UNITED STATES PATENT AND TRADEMARK OFFICE

APPLICATION NO.	FILING DATE	FIRST NAMED INVENTOR	ATTORNEY DOCKET NO.	CONFIRMATION NO.
10/524,596	02/15/2005	Rupert Nicholas Anderton	05-135	8842

Office Action Summary

DETAILED ACTION

FIG. 1

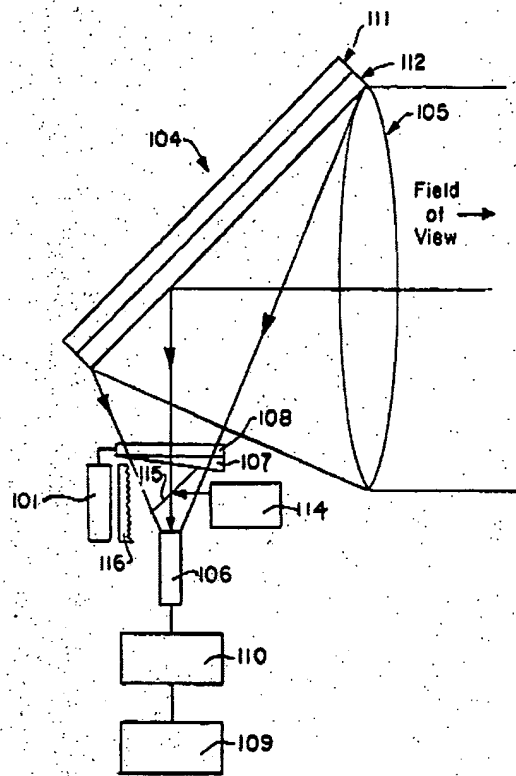
3. Hugenin discloses a millimeter-wavelength detection device comprising:
(Claim 1) at least one dielectric lens element (col.4, ln.54; Figure 1(105)),
a receive element which is sensitive to millimeter-wavelength radiation
(Abstract; col.4, ln.59; col.12, ln.32-34; Figure 1(106)),

(Claim 9) wherein a millimeter-wavelength source is arranged to periodically provide a reference signal to the receive element (local oscillator, col.5, ln.16; Figure 1(114)),

(Claim 11) wherein the direction of incoming radiation changes with time (col.8, ln.51 - col.9, ln.6; Figure 1(107)),

(Claim 14) wherein the refractive element is mounted, as to be rotatable, in the path of the incident radiation so that different rotational positions result in radiation from differing directions being passed to the receive element (col.8, ln.44 - col.9, ln.6; Figure 1(107)),

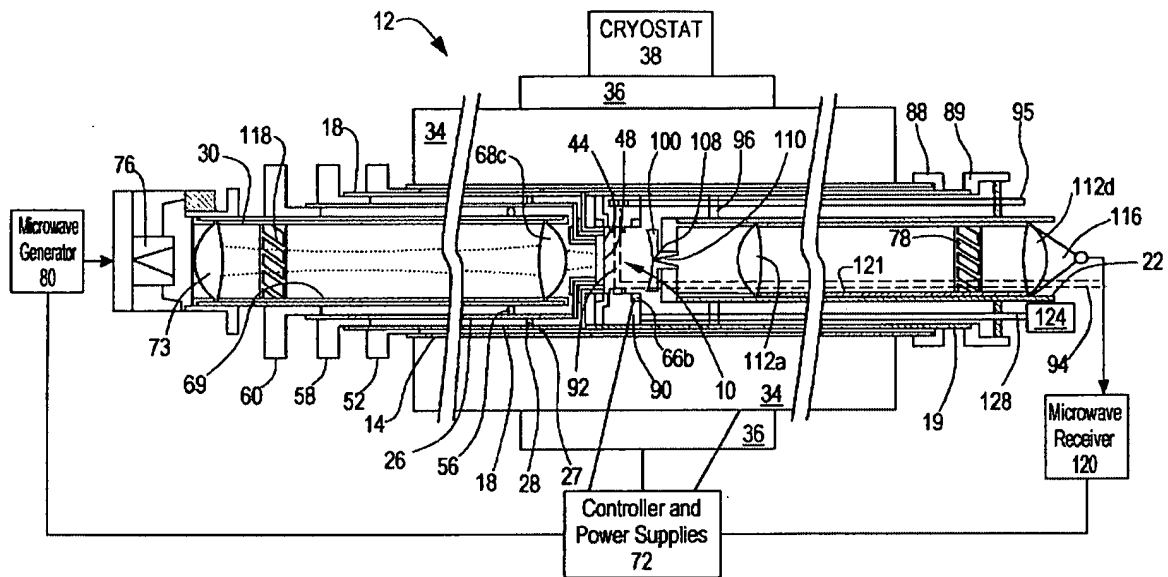
(Claim 5) a fixed quarter-wave plate and a moveable quarter-wave plate which determines the polarization of radiation incident on the receive element (col.7, ln.35-39; Figure 1A (118) and (78); col.11, ln.14-18; Figure 7 (220) and (280); Figure 8 (320) and (380)),

(Claim 7) wherein the moveable quarter-wave plate is rotatably mounted (The tube containing the quarter-wave plate (118) is fixed in orientation w.r.t. the incident radiation, while the tube containing the quarter-wave plate (78) is free to rotate. col.7, ln.46-53) and permits transmission of incident radiation such that the radiation sees the fast axes in multiple positions (A quarter-wave plate with a

fast axis, i.e. made of a birefringent medium, must allow the incident radiation to see the fast axis for any $\frac{1}{2} \pi$ rotation.) for the benefit of increased signal power received at the receive element (col.7, ln.40-45).

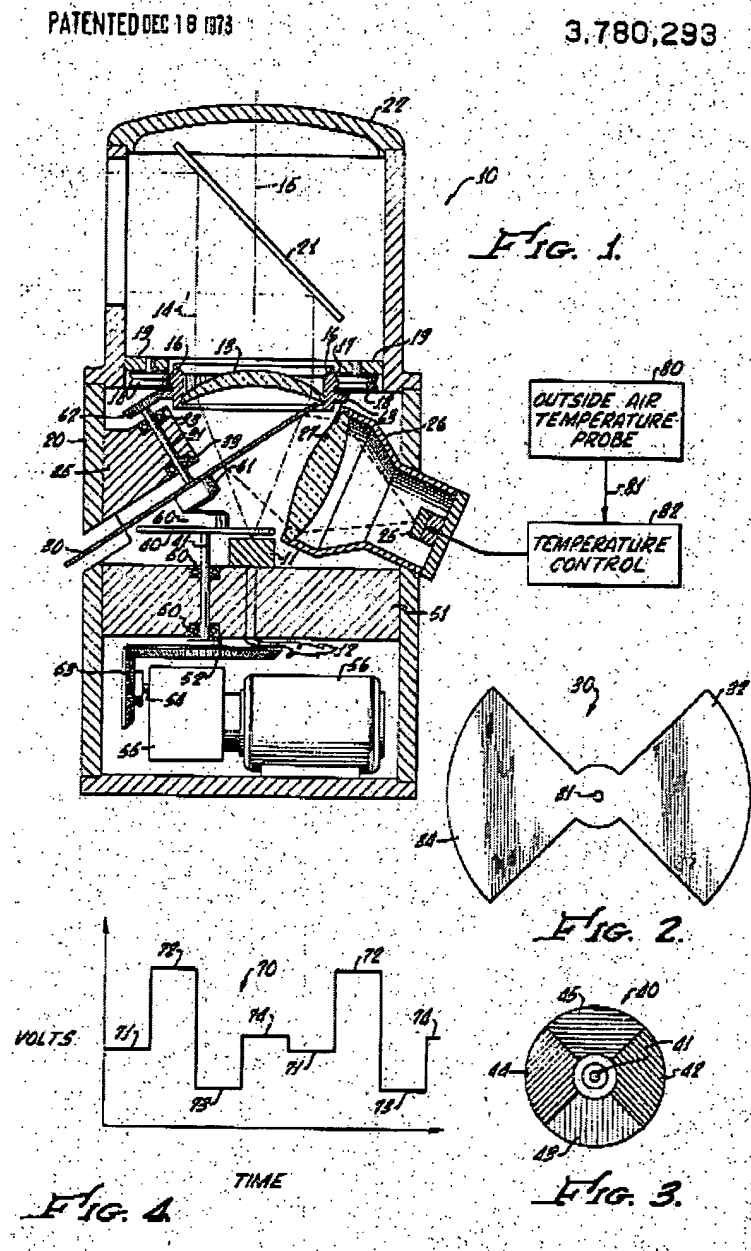
14. Epis teaches a receiver wherein the quarter-wave plates are meanderline structures (Abstract) for the benefit of a low-frequency operating limit.

15. It would have been obvious to one of ordinary skill in the art at the time the invention was made to include meanderline quarter-wave plates in the apparatus of Hugenin and Budil et al. because, as disclosed by Epis: "An advantageous and inherent characteristic of the meanderline array polarizer as compared to other prior art polarizers is that the former has no intrinsic or theoretical low-frequency operating limit" (col.1, ln.56-59).
